## SERVICE BULLETIN

**Beech****ATA CODE 11-30****TITLE: PLACARDS AND MARKINGS - INSTALLATION OF FUEL SELECTOR PLACARD****SYNOPSIS OF CHANGE**

This Service Bulletin is being issued to add placards to the fuel selector because Raytheon Aircraft Company has received reports of incidents and accidents involving Beech piston airplanes in which engine stoppage may have been caused by incorrectly positioning the fuel selector between tank detents.

Figure 1

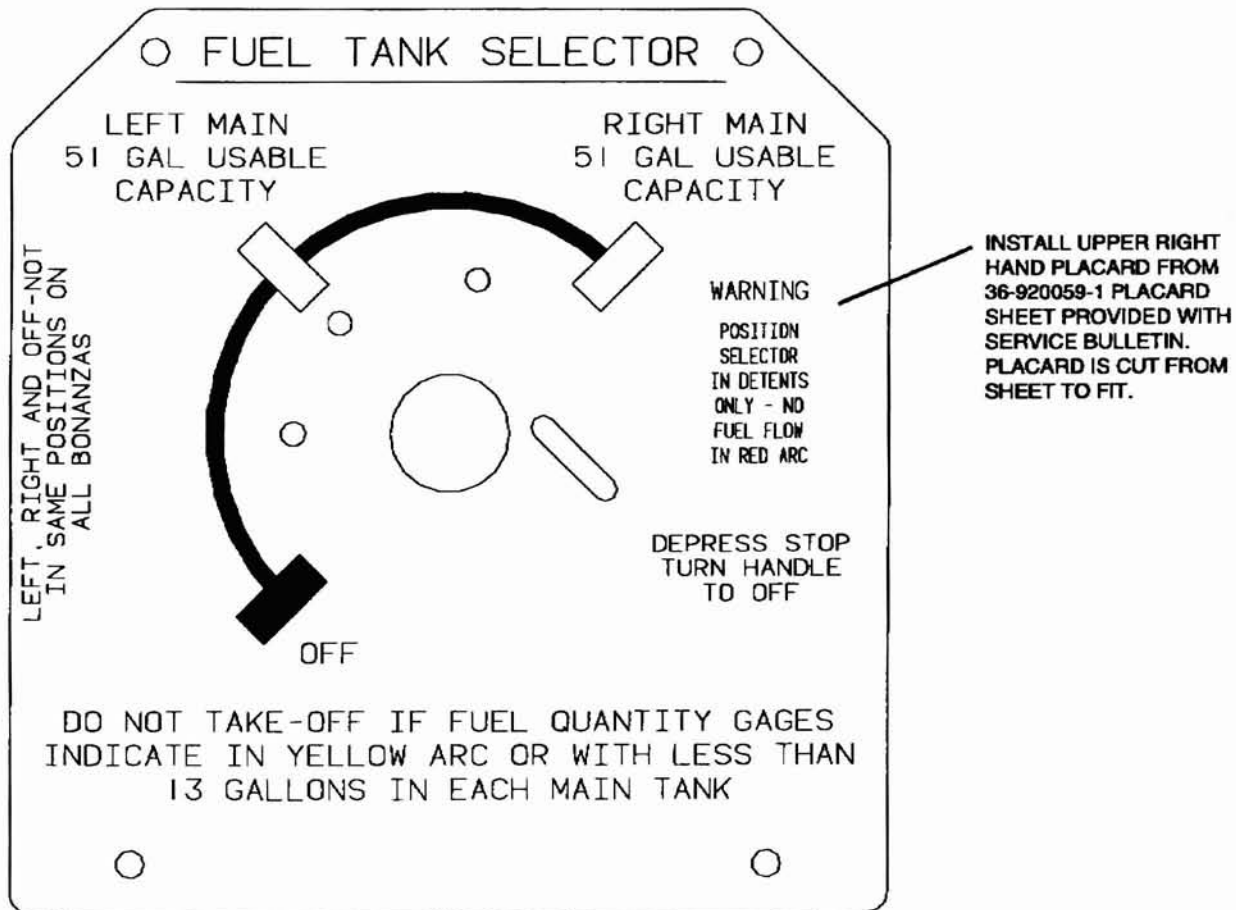
- (1) Figures 1 and 2 (and matching placards attached) are to be used primarily for the serials shown but may be used as an example of suitable configurations for typical Beech single-engine and twin-engine Beech airplanes. The no-flow sectors include the areas between tank detents and any "OFF" selection. Ensure that the placard does not cover any existing words or markings.

FUEL SELECTOR VALVE  
(B36TC SHOWN, A36TC SIMILAR)

EFF: A36TC SERIAL EA-1 THRU EA-241 AND EA-243 THRU EA-272 WITH BEECH KIT NO. 36-9008-1 INSTALLED, KIT SERIAL NUMBERS 101 THRU 389 ONLY. B36TC SERIALS EA-242 AND EA-273 THRU EA-591.

- (4) Dampen a soft cloth sparingly with solvent, and clean the face of the fuel selector valve.
- (5) Remove paper from adhesive side of the placard and affix to face of fuel selector valve.
- (6) Ensure all work areas are clean and clear of tools and miscellaneous items of equipment.
- (7) Insert Figure 3 at the end of your AFM, if applicable. If your airplane has a POH or POM, you will receive a Temporary Revision or Supplement.
- (8) Return airplane to service.

Figure 2

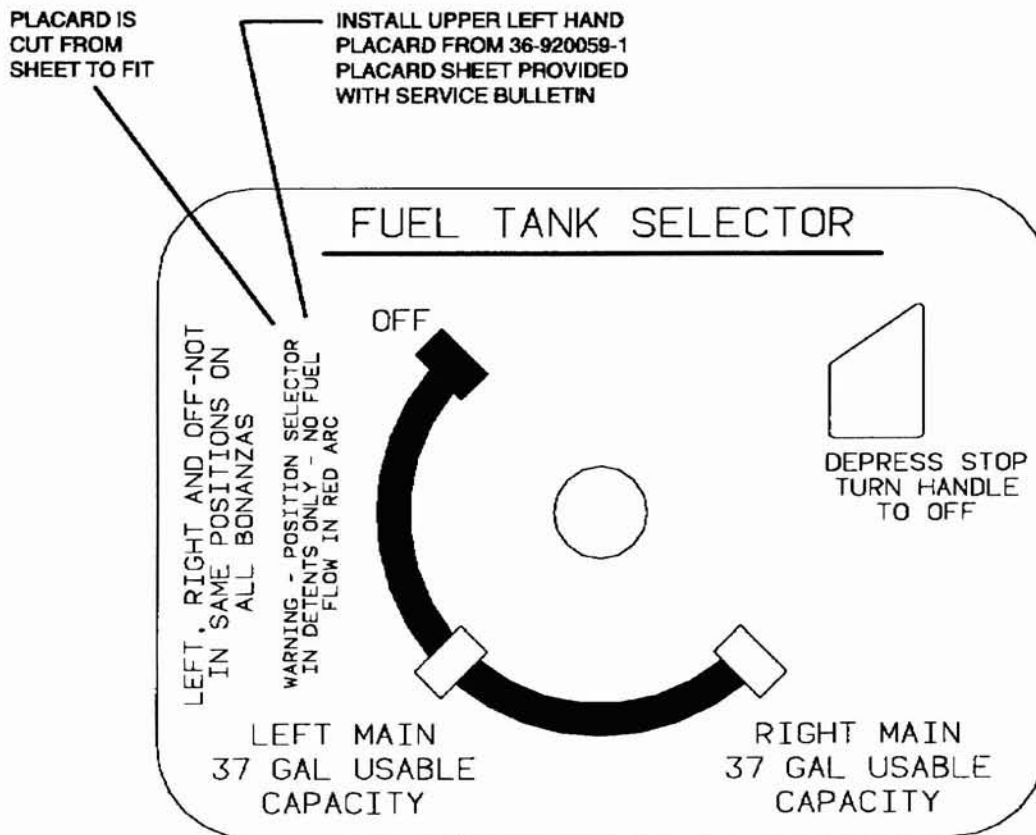
FUEL TANK SELECTOR COVER  
EFF: F33A - CE-1014 THRU CE-1791  
F33C - CJ-156 THRU CJ-179  
A36 - E-2062 THRU E-3046
